Access Compliance Report

Public Rights-of-Way

| Intersection ID: N/A | Main Street: SOUTHGROVE_ST | Cross Street: WAVERLY_WALK_AV | Location: SE |
| ADA ID: 643671DC55EA | Ramp Type: Perp | Initial Pass/Fail: Fail | Overall Compliance: No |

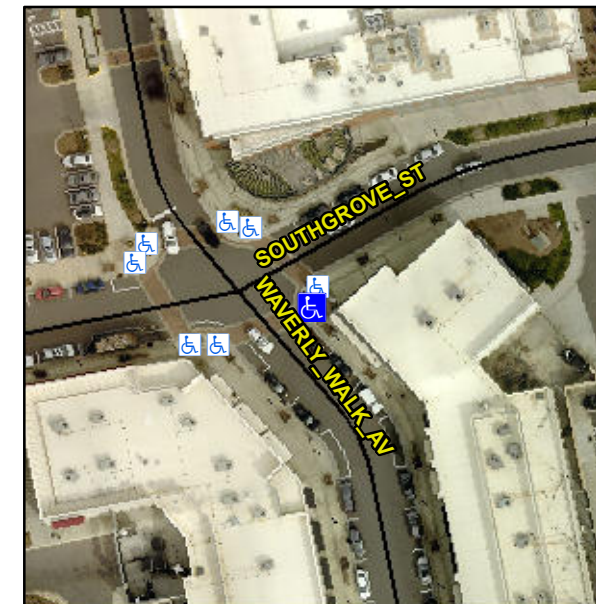
R304.5.1, R304.5.3

| Compliance | Description | Data | Compliance | Description | Data |
|------------|-----------------------|-------|------------|-----------------------------|------|
| N/A | Ramp Length (in) | 69.0 | Yes | Ramp Slope (%) | 7.5 |
| No | Ramp Width (in) | 47.0 | No | Ramp XSlope (%) | 2.3 |

Remove & Replace Entire Ramp.
